SERVICE BULLETIN #3 HOUDINI SKILL SHOT FIX

May 15, 2018

These steps need to be performed if you are unable to hit all 3 targets for the skill shot.

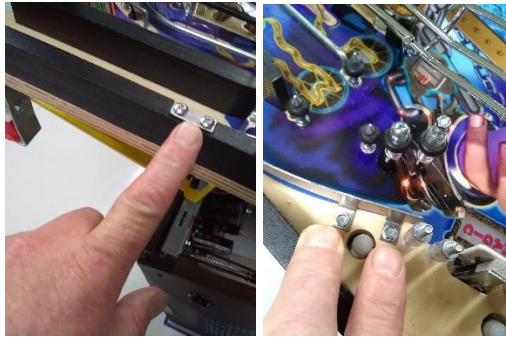
Remove the three 11/32 nuts, remove and disconnect the planchette and loosen the three Philips heads

Remove the two 1/4" nuts holding the gate on and remove the gate.

Remove the two Philips and two ¼" screws

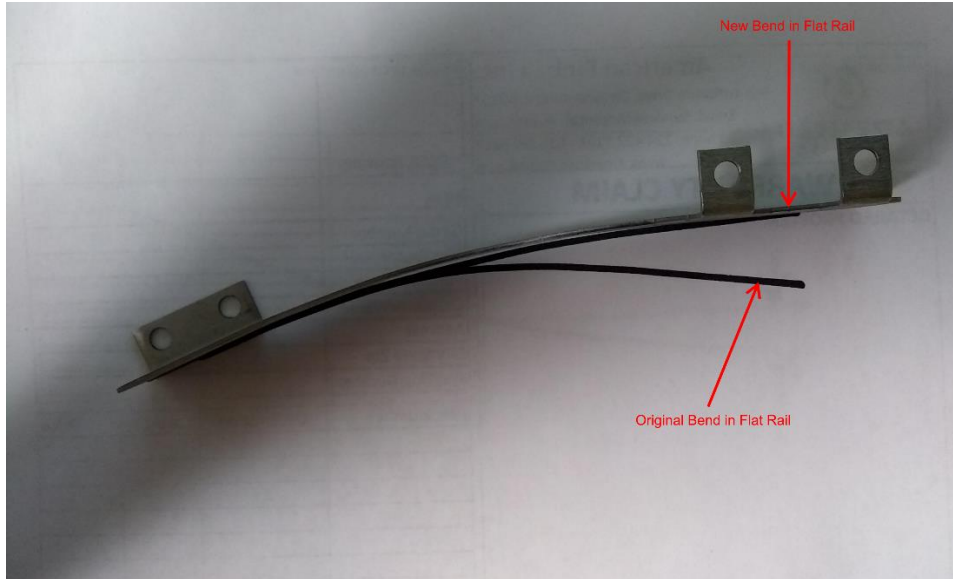
Remove the flat rail and open the radius of the curve about 1 inch.

Remove the 7/16" rubber and insert the 3/16" rubber. The post closest to the flat rail will no longer have a rubber on it. The goal is to have the flat rail touching the post without the rubber on it.

Reinstall the gate, plastic and planchette. Test to ensure the ability to hit all three stand up targets from the shooter lane.
